APPENDIX D

Consultation Record

Project Title	Pear Tree Solar Farm
---------------	----------------------

PEARTREE HILL SOLAR FARM, EAST RIDING OF YORKSHIRE.

Figure 1: Locations on the River Hull which intersect the red line boundary for the site where breaches are not proposed.

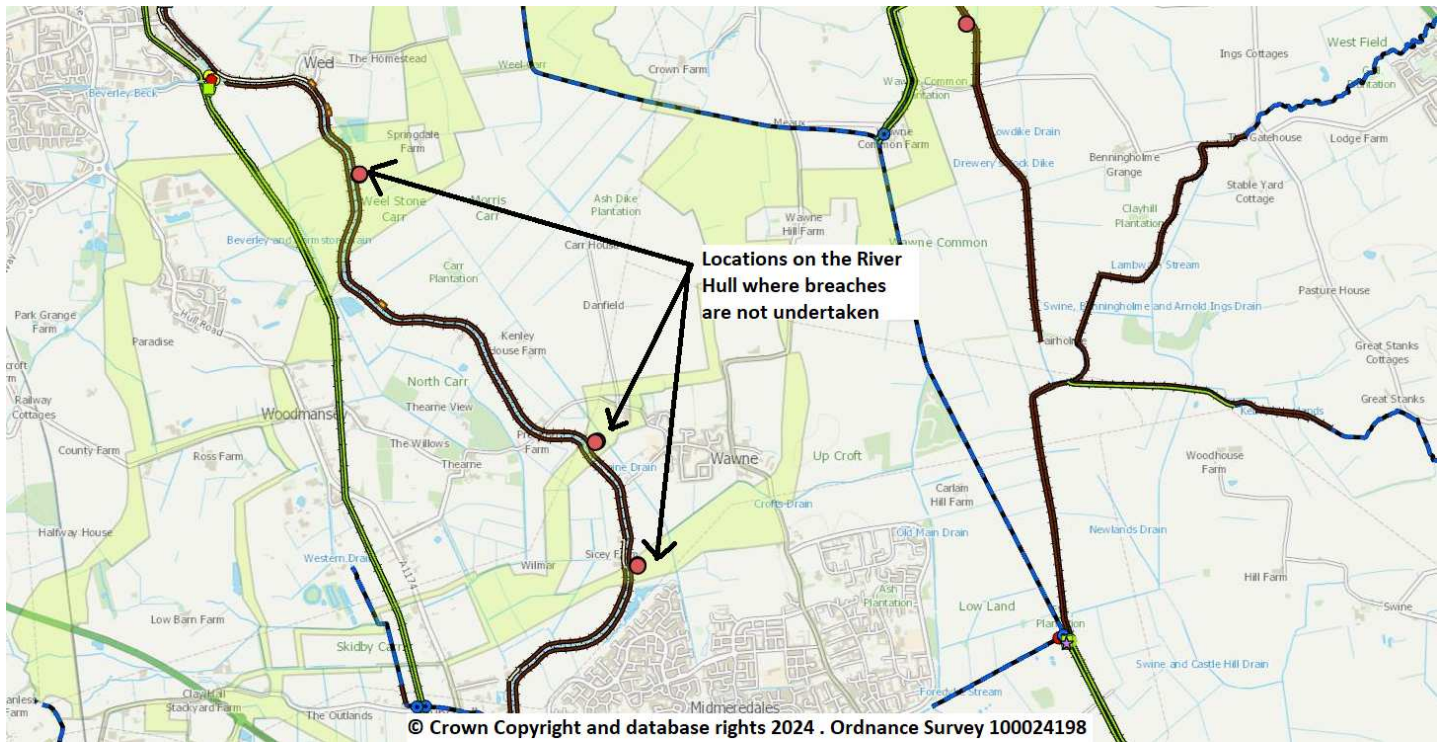
What was the rationale for not undertaking a breach at east 506700 north 438725, east 508280 north 436920, and east 508565 north 436090 on the left and right bank of the River Hull (figure 1 below)? Is this because these are relatively low risk areas for cable routing?
